ADDENDUM NO. :	Three (3)
BID DUE TIME AND DATE:	2:00 p.m., April 30, 2019 (No Change)
BIDDER QUESTIONS BY:	11:59 a.m., April 23, 2019
LAST ADDENDUM ISSUED:	11:59 p.m., April 25, 2019

BID NUMBER: BID-SJR-06-2018
RENOVATION WITH ADDITION TO BUILDING V ST. AUGUSTINE CAMPUS

ST. JOHNS RIVER STATE COLLEGE

04/17/19 ADDENDUM 3

B4 SECTION
SCALE: 1 1/2" = 1'-0"

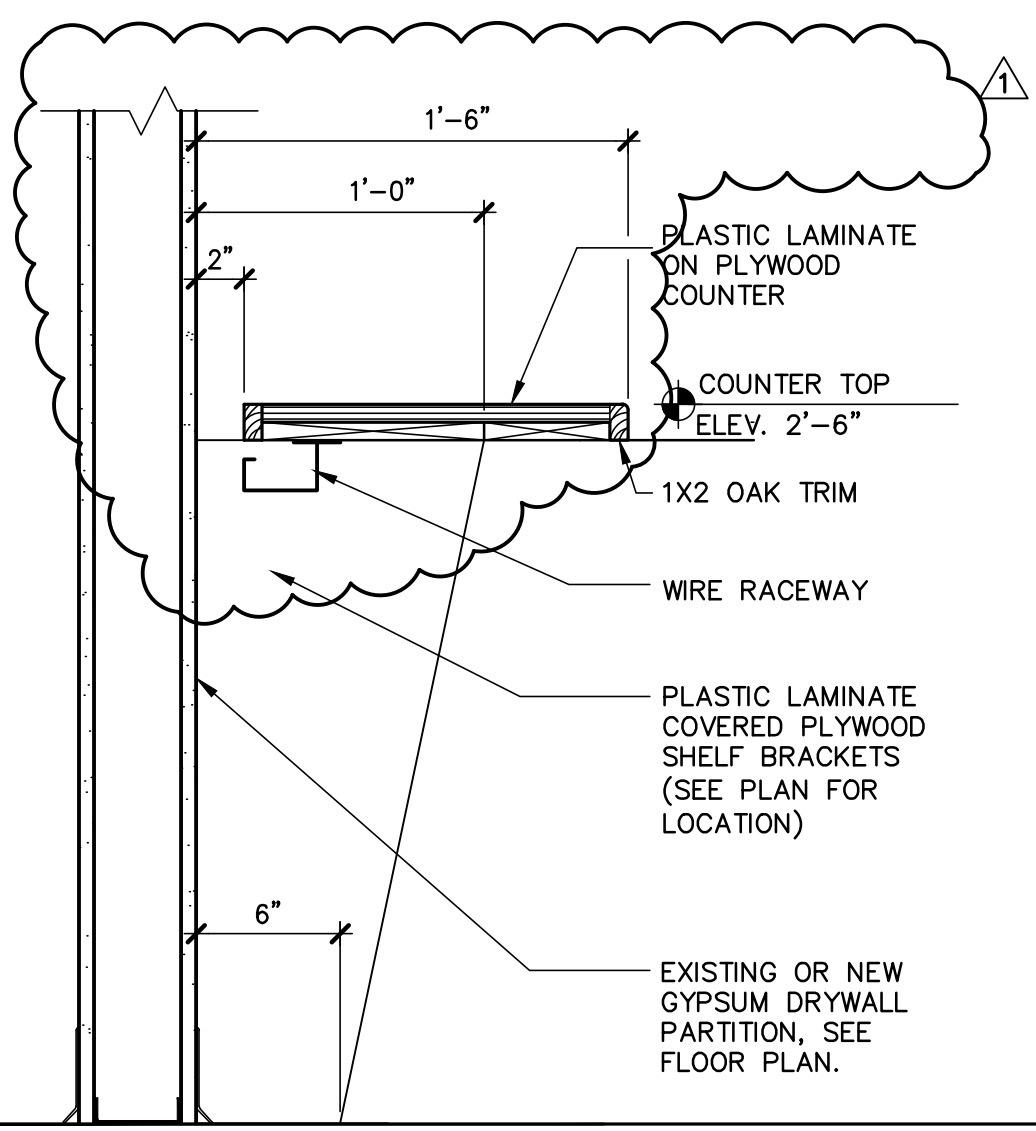
Q1: Millwork Counter Locations: B4/A501 indicates counters in (5) location which cannot be found on the drawings for conference cubicles and work stations. [NOTE: A501 has been revised and included with this Addendum 03].

A1b: Section B4/A501: Besides revising quantity/location, counter width decreased.

A1: That note should be deleted; it is incorrectly carried over from a previous job. The section only applies to one location, the south wall of the Community Space V0112 seen on elevation A5/A501 (also seen on B1/A301). Number of vertical shelf brackets.

B5 SECTION
SCALE: 1 1/2" = 1'-0"

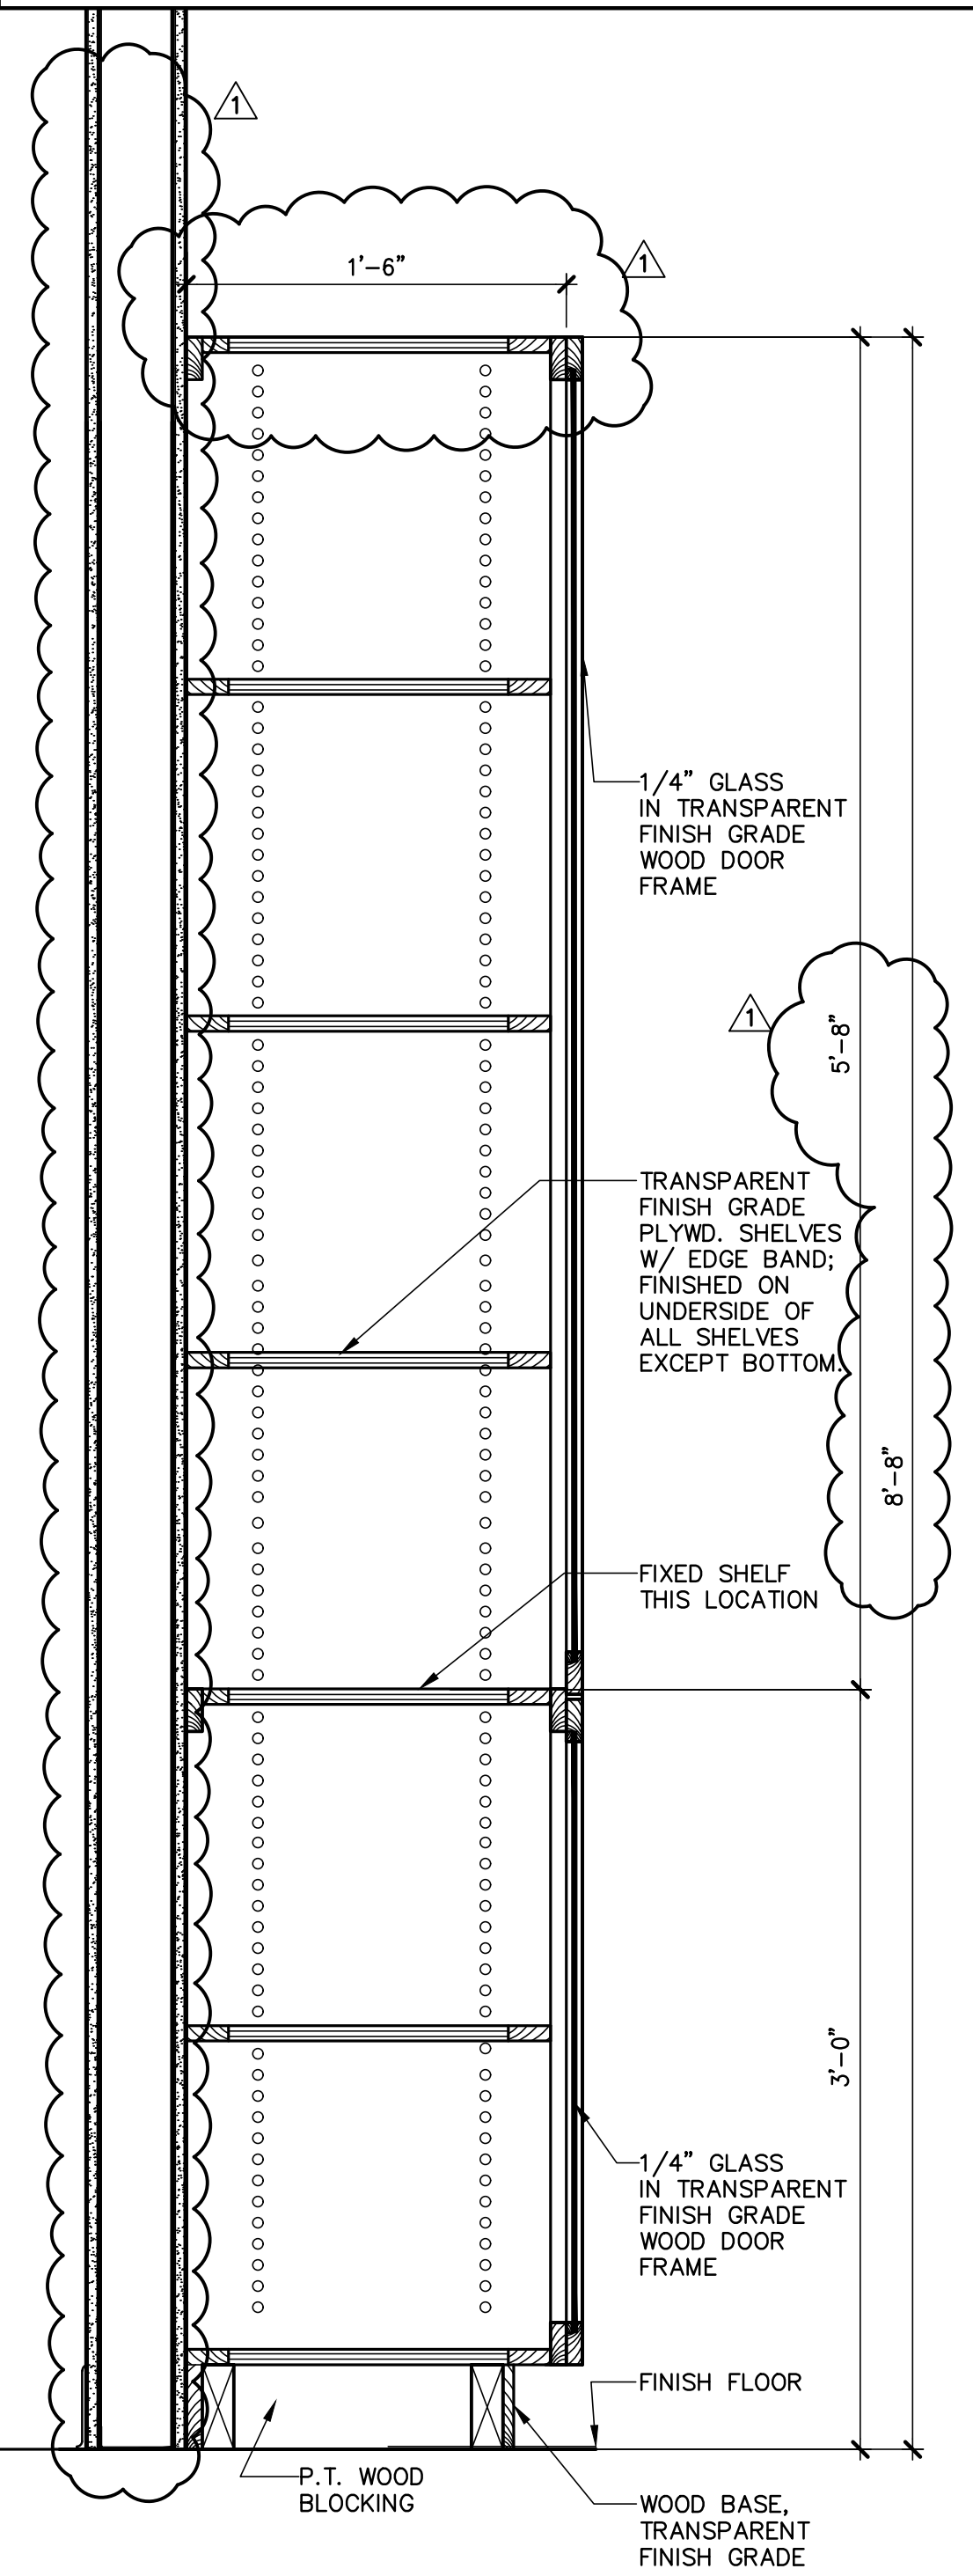
A1c: Section B5/A501: Revised height (shortened from 9', to 8'-8"), width increased from 1', to 1'-6; and wall behind shown as gyp bd, not storefront.

A1 FRAME TYPES

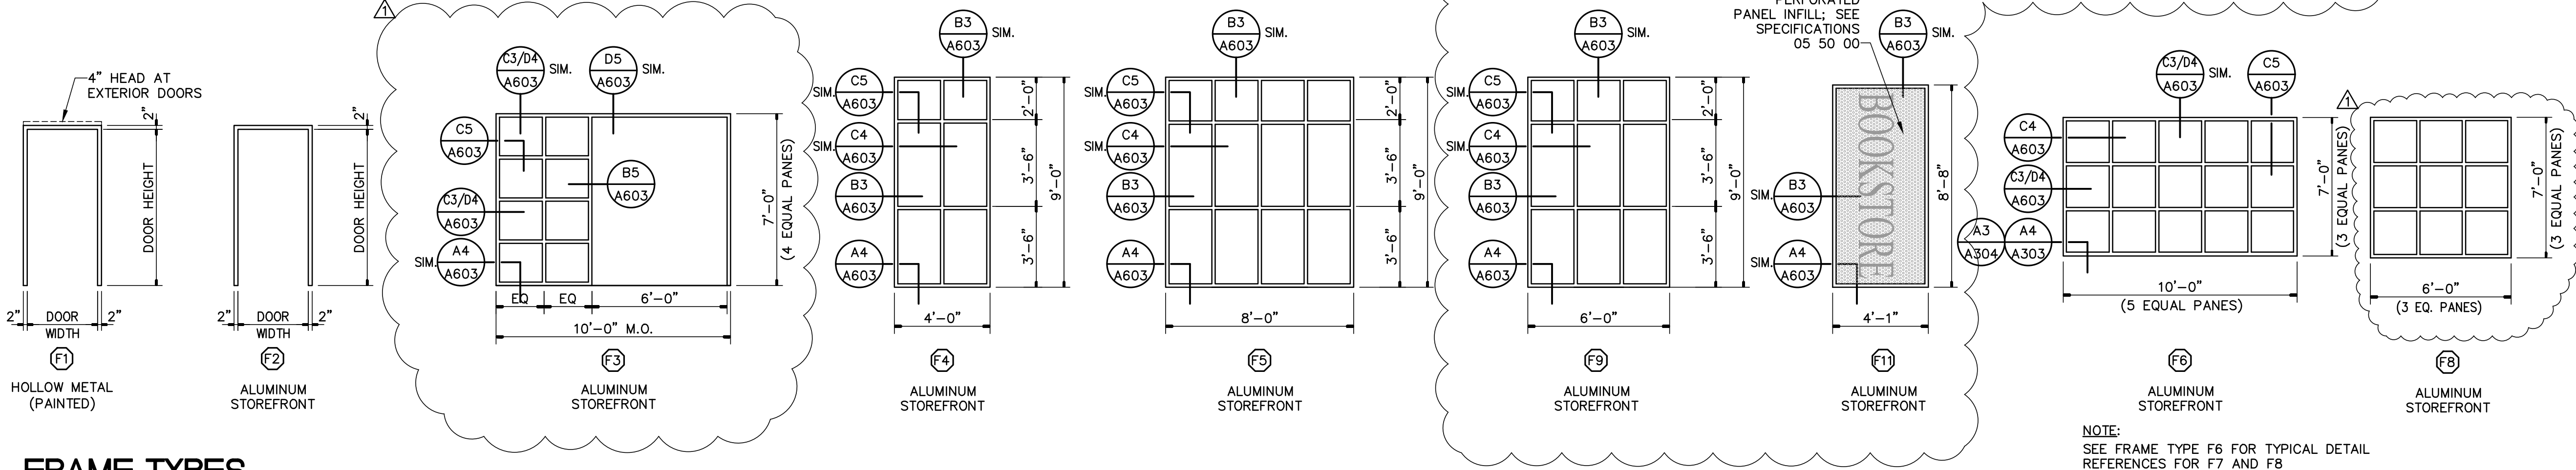
Aluminum storefront windows: Locations shown for aluminum storefront windows. Exterior for Addition shown on A101, including identifying the storefront at 10' AFF. Interior shown on A102 including identifying the storefront at 10' AFF. Also added Type F9, F10, and F11:

- F9 shows rectangular interior storefront, similar to F4 and F5 but with 6' width dimension. Visible in A1/A302 (left storefront in that Section incorrect/should match two to the right/north).
- F10 shows triangular interior storefront starting 10' AFF and visible on B1 and C1/A301.
- F11 shows rectangular interior storefront with perforated panel, similar to F4 but without internal mullions, and visible on A1/A301 with "BOOKSTORE" graphic.
- F3 adjusted to reflect Floor Plan with Doors off-center.
- F8 corrected to 6' wide panel (located at 10' AFF, south end of col line 6.)
- F7 (located 10' AFF) shifted above its lower window counterpart, and horizontal intermediate mullion corrected.
